**ADDENDUM NO. 1**

**March 13, 2025**

**Project: City Critical Facilities Generators Project  
TDEM HMZGP 4332-0126**

**Owner: City of Taft, Texas**

1 TYPICAL BOLLARD DETAIL  
SCALE: N.T.S.

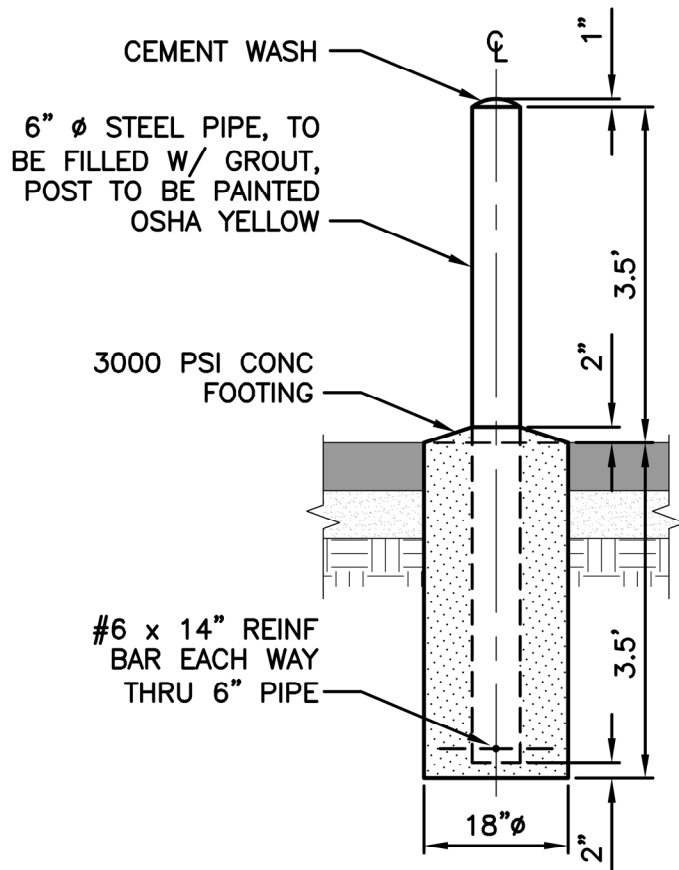
1. Please replace the Original Bid Proposal with the attached Revised Bid Proposal dated March 13, 2025.
2. The proposed generator locations shall be per the site plans issued.
3. All four (4) generator sites shall include 4 each concrete bollards around each generator. Please see detail attached. This item shall be subsidiary to the appropriate bid item(s).
4. Please replace Plan Sheets ES1.0, E1.0, E1.1, and E2.0 for the Community Center (Kiva Hut) Generator with the attached revised Plan Sheets with change date of 03/12/2025.
5. The Contractor shall provide at the Water Treatment Plant (WTP) Generator a diesel tank subbase tank (doubled wall meeting TCEQ containment requirements) sized for a minimum 48-hour run time.

**1 ELECTRICAL SITE PLAN**  
 ES1.0 SCALE: 1" = 30' 0"

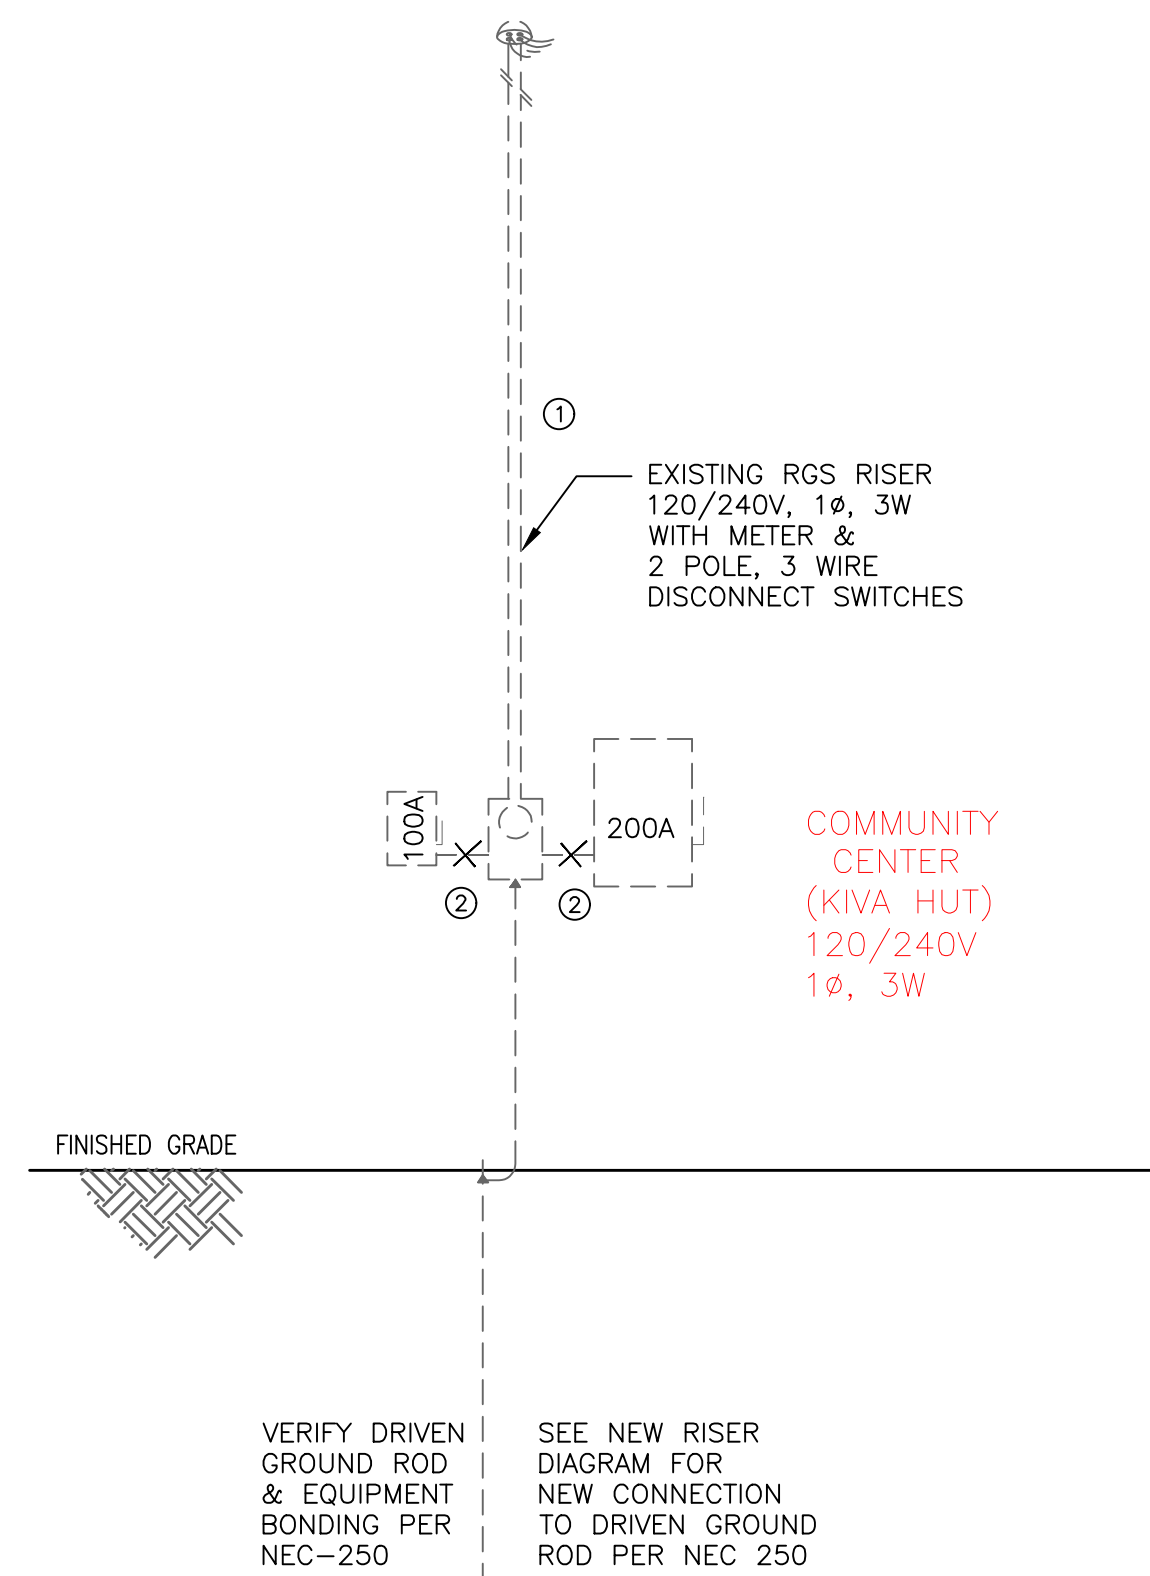
03/12/25  
 CHANGE GENSET FROM 40KVA 3Ø TO 40KVA 1Ø AND ADD PHASE CONVERTER

PROVIDE NEW 40KW (50KVA) NATURAL GAS FIRED GENERATOR (WEATHERPROOF ENCLOSURE) 120/240V, 1Ø, 3W GENERATOR WITH CONCRETE BASE SIZED PER ACTUAL GENSET INSTALLED (GENERAC XG0404SNAX OR EQUAL) INSTALLATION SHALL BE IN COMPLIANCE WITH TCEQ FOR STANDBY GENERATORS.

VERIFY ALTERNATOR PROVIDES 120/240V, 1Ø 3W POWER TO MATCH INCOMING NORMAL POWER FOR KIVA HUT AND TO FIRE STATION POWER AT 3 PHASE (VIA PHASE CONVERTER).

**2 NEW ELECTRICAL RISER DIAGRAM - COMMUNITY CENTER**  
SCALE: NTS

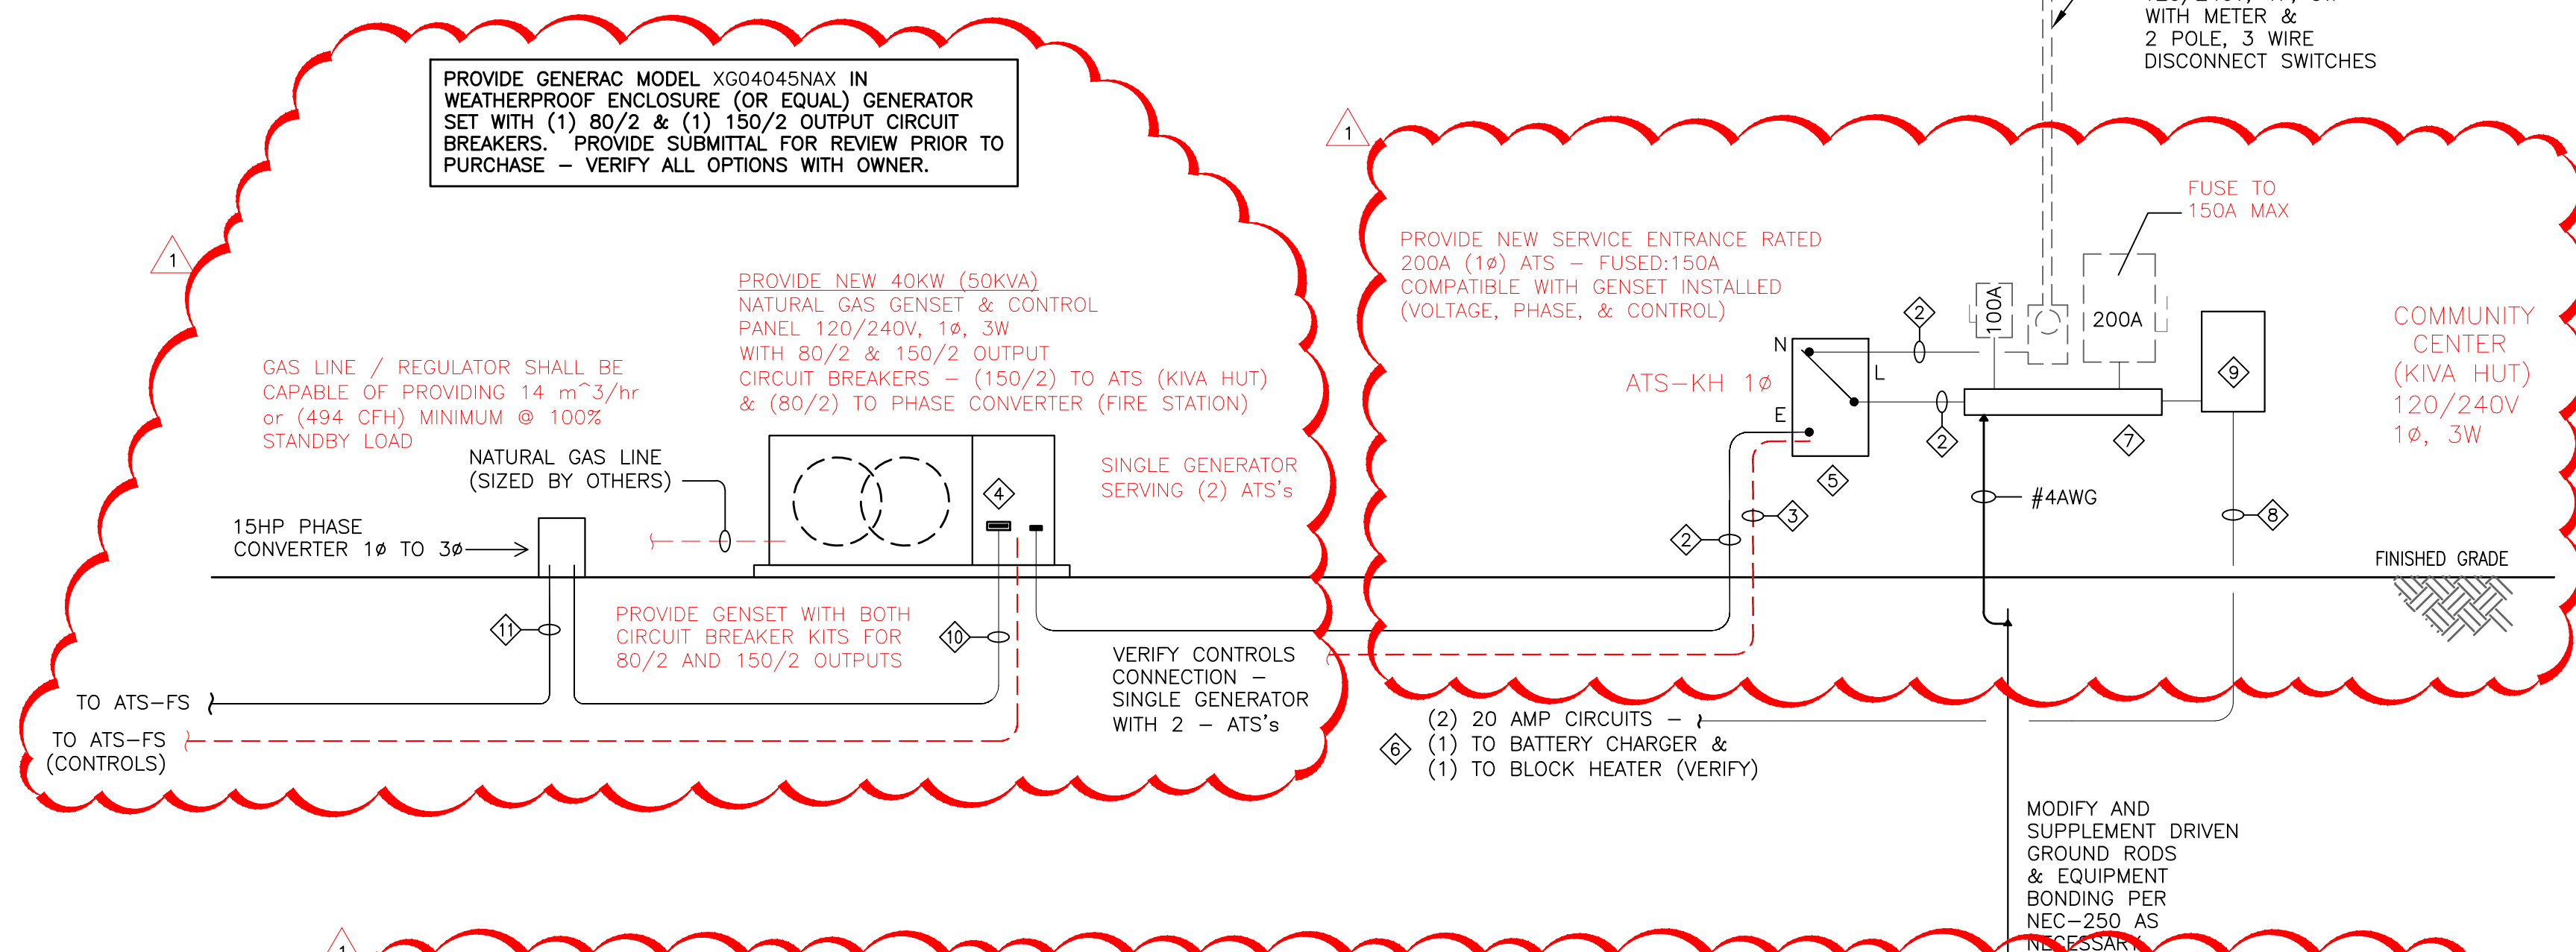
① 03/12/25  
CHANGE GENSET FROM  
40KVA 3Ø TO 40KVA 1Ø AND  
ADD PHASE CONVERTER

- ④ SEE NOTE 4 ON SHEET E1.1 FOR OUTPUT CIRCUIT BREAKERS ON GENSET - 80/2 CB FOR FEED TO (PHASE CONVERTER - FIRE STATION) & 150/2 CB FOR FEED TO COMMUNITY CENTER.

- ⑤ PROVIDE 200A, 240V, 1Ø, 3 WIRE, 2 POLE, FUSED:150A AUTOMATIC TRANSFER SWITCH (SERVICE ENTRANCE RATED) - COMPATIBLE WITH GENERATOR SET INSTALLED. PROVIDE COMPLETE CONTROL WIRING FROM ATS CONTROL PANEL TO GENERATOR CONTROL PANEL (OR OTHER ATS AS NECESSARY). COORDINATE ALL REQUIREMENTS WITH SPECIFIC GENSET INSTALLED.

**2** NEW ELECTRICAL RISER DIAGRAM - FIRE STATION  
E1.0 SCALE: NTS

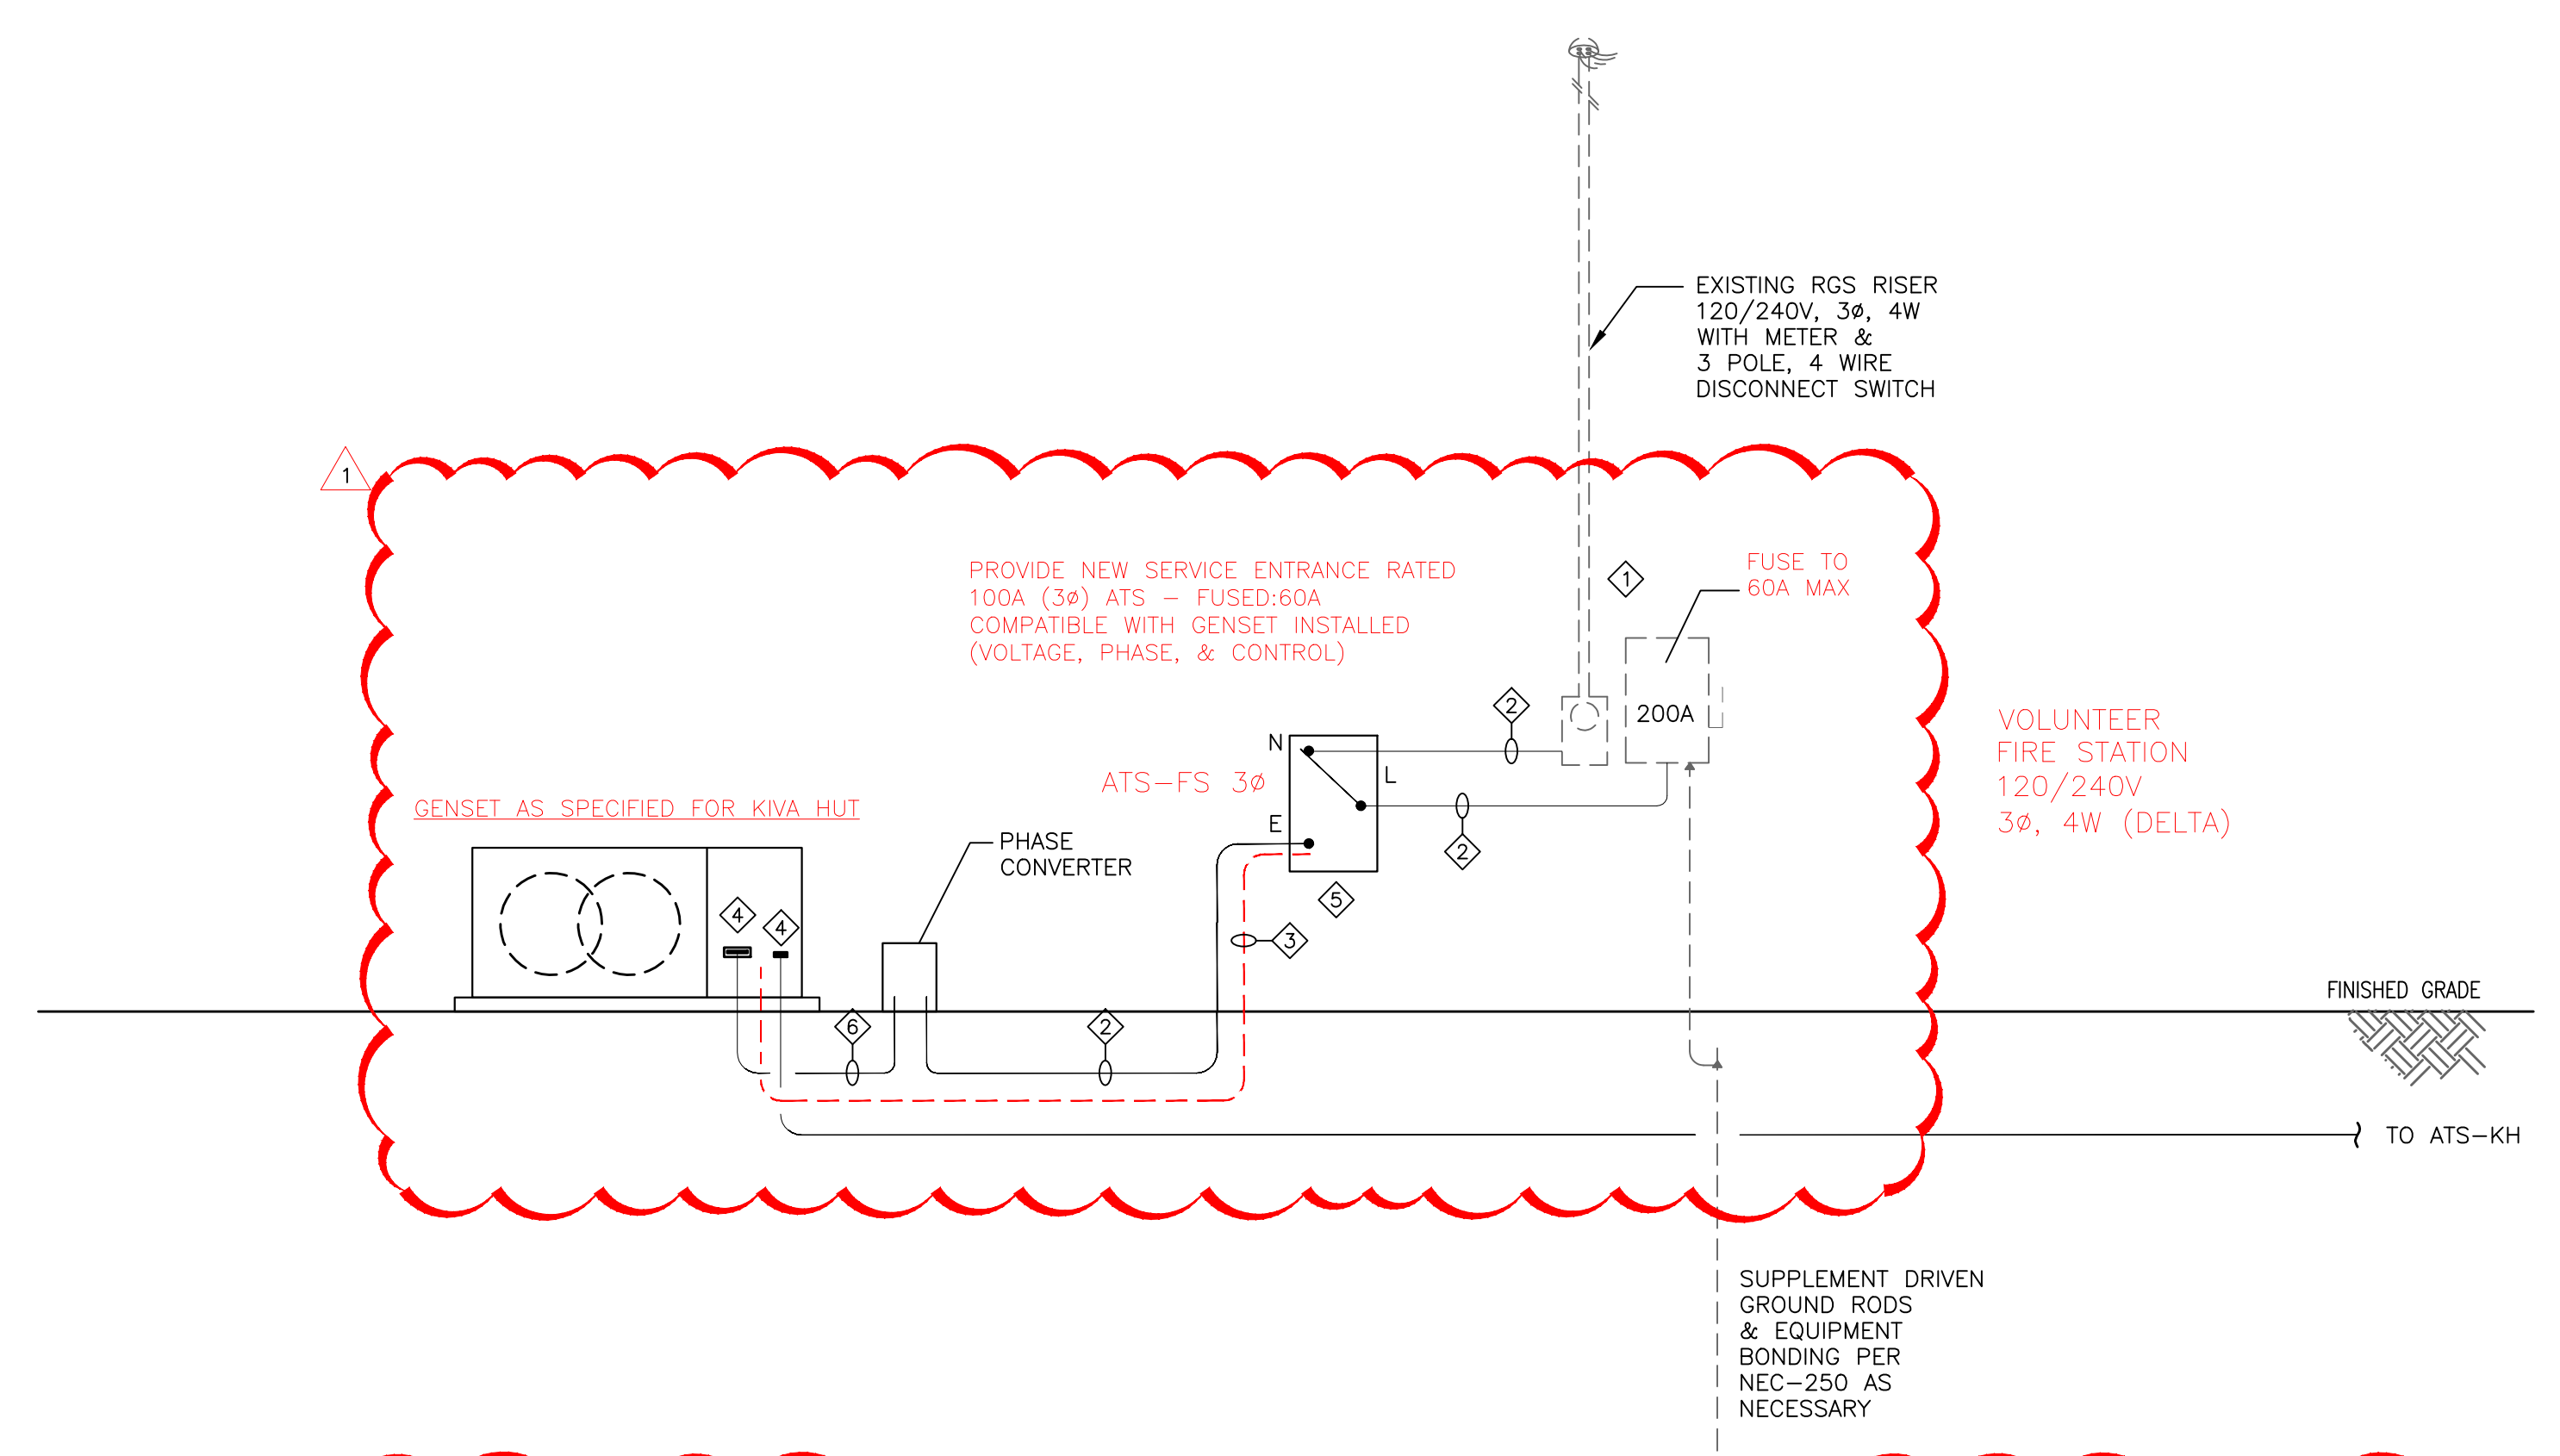
① 03/12/25  
CHANGE GENSET FROM 40KVA 3Ø TO 40KVA 1Ø AND ADD PHASE CONVERTER

- ② PROVIDE 4#6 #8G, 1 1/2"Ø.
- ③ PROVIDE CONTROL WIRING AS REQUIRED FROM 1Ø ATS (KIVA HUT) TO FIRE STATION 3Ø ATS (VIA PHASE CONVERTER), VERIFY INSTALLATION WITH ACTUAL EQUIPMENT PROVIDED (WIRING DIAGRAMS).

- ④ PROVIDE CONNECTION TO RESPECTIVE OUTPUT CIRCUIT BREAKER AT NEW 40KW (50KVA) GENSET. PROVIDE GENSET WITH 60/2 CB FOR FEED TO FIRE STATION (VIA PHASE CONVERTER) & 150/2 CB FOR FEED TO COMMUNITY CENTER ATS (KIVA HUT). SITE VERIFY ALL CONDITIONS PRIOR TO ANY ELECTRICAL ROUGH-IN.

- ⑤ PROVIDE 100A, 240V, 3Ø, 4 WIRE, 3 POLE, FUSED:60A AUTOMATIC TRANSFER SWITCH (SERVICE ENTRANCE RATED) - COMPATIBLE WITH GENERATOR SET INSTALLED. PROVIDE COMPLETE CONTROL WIRING FROM ATS CONTROL PANEL TO GENERATOR CONTROL PANEL. COORDINATE ALL REQUIREMENTS WITH SPECIFIC GENSET INSTALLED.
